**REQUEST FOR COUNCIL ACTION**

Originating Department <b>Community Development</b>	By <b>GPD</b>	Approved for Agenda by:	Date:  Time:	Number:
Agenda Section <b>DEVELOPMENT BUSINESS</b>		Item <b>Rezone from CB(PD) to CB, Preliminary Plat, Conditional Use Permit, and Final Site Plan and Building Plans</b>

Case 10329ABC-97

Rezoned from CB(PD) to CB, Preliminary Plat, Conditional Use Permit, and Final Site Plan and Building Plans

#### **SITE PLAN**

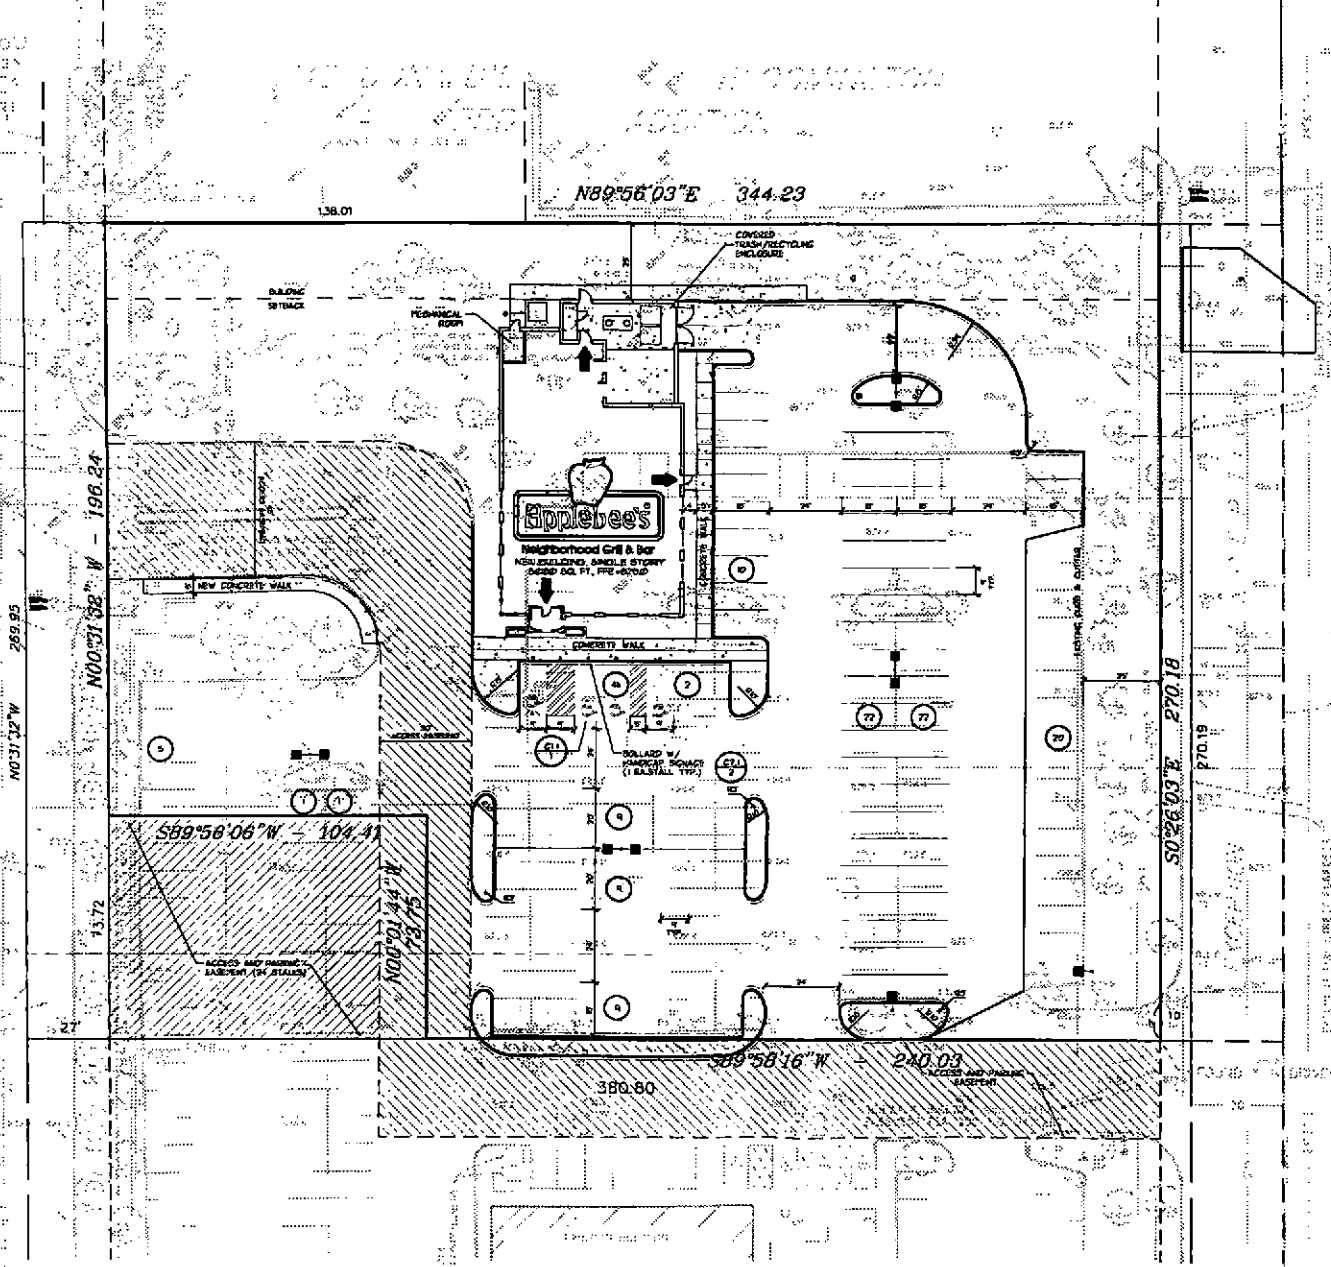
The restaurant has been oriented more to the interior of the site than to Lyndale Avenue with the building entrance on the south side and parking located predominantly to the south and east. This orientation places the entrance convenient to most of the parking. The facility will share the north driveways to Lyndale and Garfield Avenues under appropriate access/circulation easements. The applicant has not submitted any revised plans consistent with the revised preliminary plat relocation of the south property line for proposed Lot 1.

Staff has noted the inconsistency of the submitted plans, but the most significant plan deficiency is the enclosed trash room on the northeast corner which is not "within" the building as it is not fully enclosed, but has open areas along the wall elevations. The facility must be within the building and the applicant has been advised of this situation. They have indicated that corrections will be made to make the trash room comply by completing the wall closures. Building plan inconsistencies have been corrected to show the trash access door on the east side through a metal overhead door. It would appear those building detail corrections can be made without noticeable change to the general site plan and can be adequately covered by condition.

**FRONT ELEVATION**

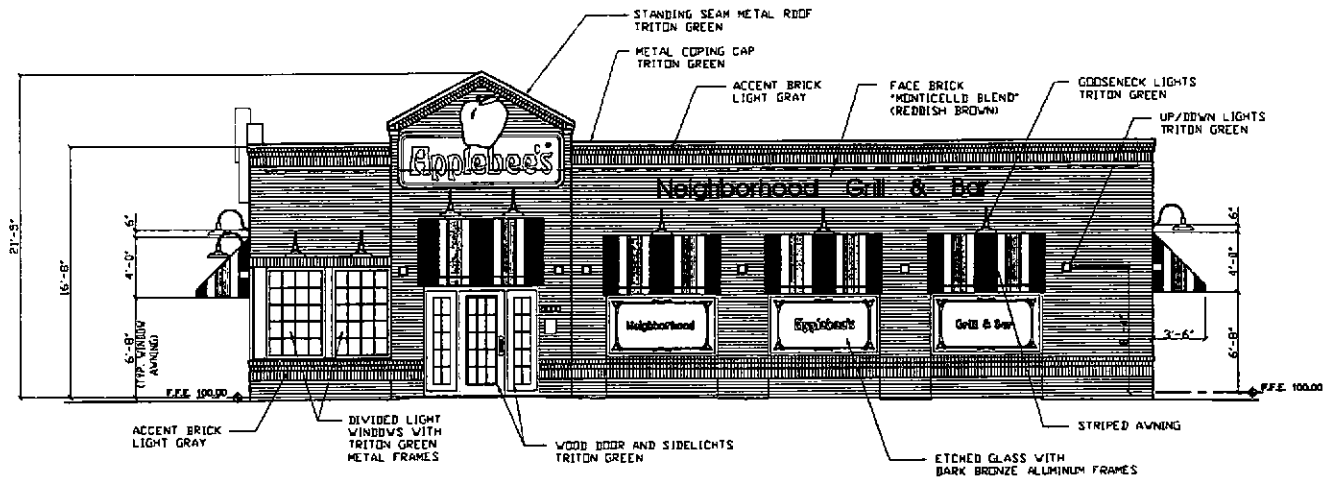
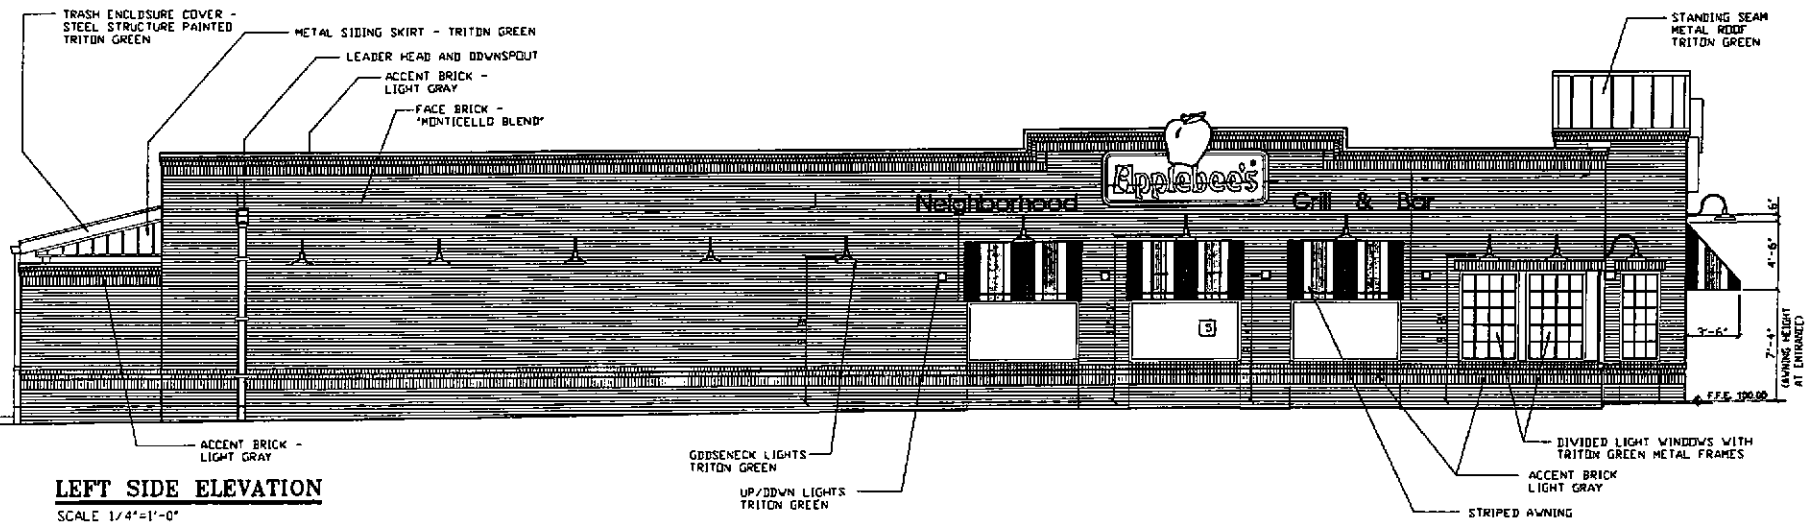
Additional information is required for both the lighting plan and the sign plan, which can be addressed prior to any permit issuance. It is noted that the drawing submitted (and attached to this report) indicate that both cabinet signs and channel letters are shown on the walls. This is not permitted by the sign code.

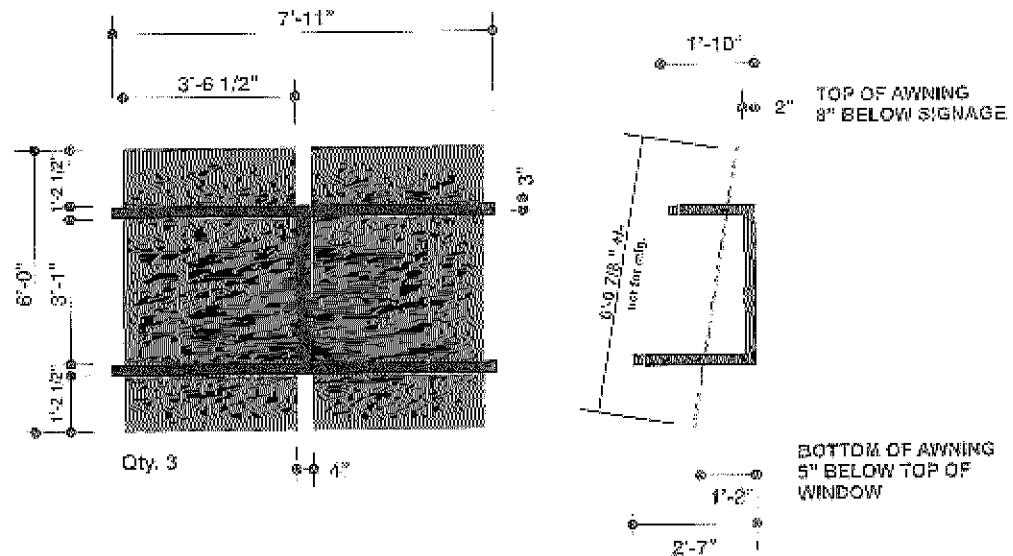
Sheet L13 does not have the square footage of the existing "Neighborhood Grill & Bar" sign. Could you please send me an updated sheet with that calculation.

Yes I will send it on Monday. They are the same size as the ones on the front elevation. Also the added specs for the lighting on the eyebrow which is  
The fixture type is: HALO LIGHTING / PART# H27-RT FIXTURE  
HALO LIGHTING / PART# 70P LENS  
60W A19 MEDIUM BASE BULBS
